PAPER No. 220.

THE WATERSUPPLY OF THE SUN ECLIPSE FAIR AT
THANESAR.

By D. A. HOWELL, M. INST. C.E., M.I., MECH. E.

LAYOUT OF WATER SUPPLY WORKS FOR THE 1936 FAIR

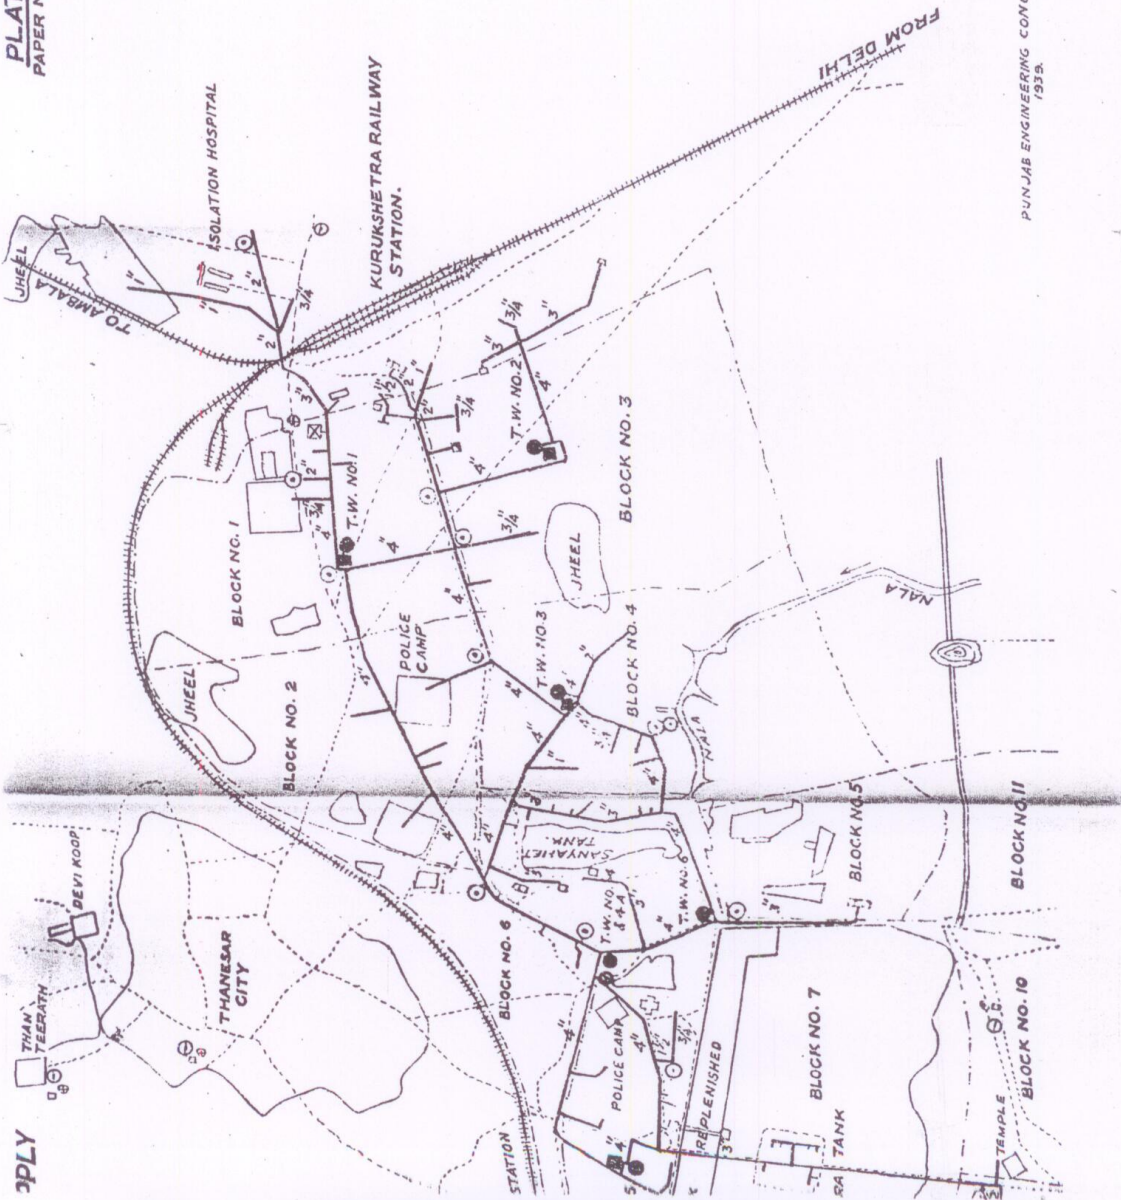
It appeared that a 4" *i/d* distribution system was rather on the small side taking into consideration the large quantity of water such as 10,000 gallons per hour passing through it, and it would be interesting to know from the Author as to what was the terminal head like at various stand posts.

The 4" distribution pipes were found in practice to be of adequate size for the supply of the water required. Pressure gauge readings of terminal heads were not available but the Author knew that each stand-post supplied its fair share of the water and no difficulties were experienced on that score.

THANESAR SUN-ECLIPSE FAIR WATER SUPPLY
VERTICAL SECTIONS OF TUBE WELLS
SHOWING LOCATION OF STRAINERS AND PLAIN PIPES

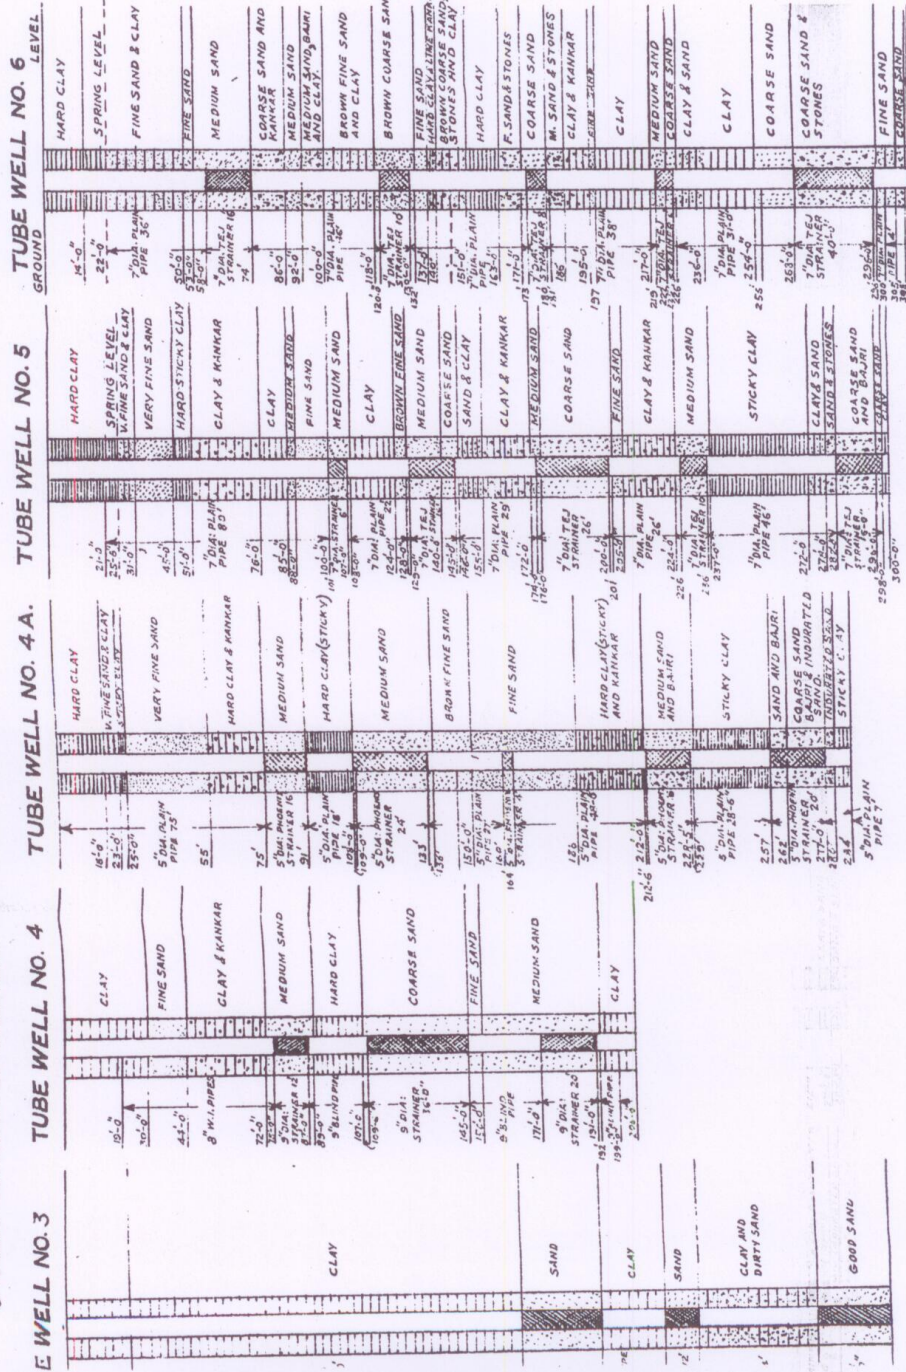
At Kurukshetra the source of supply consists of tube wells in which the spring level was about 26 feet below the surface and the arrangements for lifting water consisted of oil engine driven centrifugal pumping plants, except at Tube well No. 6 where an air lift was employed. From the data given on plate II, the areas of strainers in various tube wells were as follows :—

Tubewell No. 1	..	59	square feet.
„ No. 2	..	66	„ „
„ No. 3	..	117	„ „
„ No. 4	..	160	„ „
„ No. 4-A	..	105	„ „
„ No. 5	..	136	„ „
„ No. 6	..	143	„ „

On page 33, it was given that the combined capacity of six tube wells i.e., tube wells 1 to 5 was 63,000 gallons per hour or 98 gallons per square ft. of strainer which, according to the yield of tube well No. 4 showed that these tube wells were being worked at 10 to 11 ft. depression head. These tube wells were operated by oil engine driven, centrifugal pumps except tube well No. 6 which was worked by air lift.

On page 35 the Author stated that a large tube well i.e., tube well No. 6 was bored to a depth of 309 ft. with 78 ft. length of strainer.

It was a pity that this tube well although taken down so far below, had actually less strainer area than tube well No. 4 due to the diameter of the strainer being less.

This was presumably due to the dia. of boring being small and if a 9" i/d strainer had been provided in place of 7", the yield would have been easily 40 per cent more.

On the same page, the Author stated that by employing air lift, tube well No. 6 gave 29,000 gallons per hour. This worked out to 203 gallons per square ft. of strainer area which was 2.1 times the yield per sq. ft. of strainer area as compared with other tube wells.

For a fair watersupply scheme it was necessary to get the required quantity of water for a few days in a year or in few years, even at sacrifice of efficiency which would not make any appreciably great difference in cost, etc., and accordingly there was no reason whatever why these tube wells should not be worked to 40 or 50 ft. depression head and thus extract out of the tube wells three to four times the quantity of water now being extracted. The positions of strainers in tube wells No. 1 to 5 on plate No. II rendered this practicable.

He would like to ask Mr. Howell for a little more information about the tube wells themselves and their operation. He had taken out certain data from Plate II and from the text of the Paper, which he thought were important to those interested in the tube well side of the scheme.

T.W. No.	Depth.	Diameter.	Type.	Strainer length.	Discharge.
1	290'	7"	?	32'	10,000 g.p.h.
2	284'	7"	Tej	36'	"
3	294'	7"	?	64'	"
4	205'	9"	!	68' }	23,000 g.p.h.
4A	284'	5"	Phoenix	80' }	
5	300'	7"	Tej	74'	14,000 g.p.h.
6	309'	7"	Tej	80'	29,000 to 30,000 g.p.h.

It would be seen that five out of the seven pipes were 7" in diameter, but Nos. 4 and 4A were 9" and 5" respectively. He would like to know if this was due to a larger discharge being required when No. 4 was sunk and a lesser discharge being required when No. 4A was sunk or whether there was any other reason for adopting these 9" and 5" tubes. In the case of tubewell No. 3, although the strainer length was twice the length of Nos. 1 and 2, the same discharge was obtained, with the same power plant. In the case of No. 5 it would be seen that with a length of 10 feet of strainer more than No. 3, an increased output of 4,000 gallons p.h. was obtained, but in the case of No. 6 with only 6 feet more strainer

The level of the water table was shown on Plate II in the case of wells Nos. 5 and 6, but not in the other cases. It would be interesting to know if it was lower at other sites, as Nos. 5 and 6 were near the tank, and the water table may have been affected by seepage from it. A higher water table would undoubtedly improve the discharges.

The **Author** replying to the remarks of S. Hukum Singh stated that it was usually possible to force down the water level in tube-wells by surging with compressed air but experience had shewn that very often such method did not increase the discharge through an old incrustated strainer.

The various tubewells had to be put down in a hurry and the time available was the most important factor in selecting the size of boring and strainer.
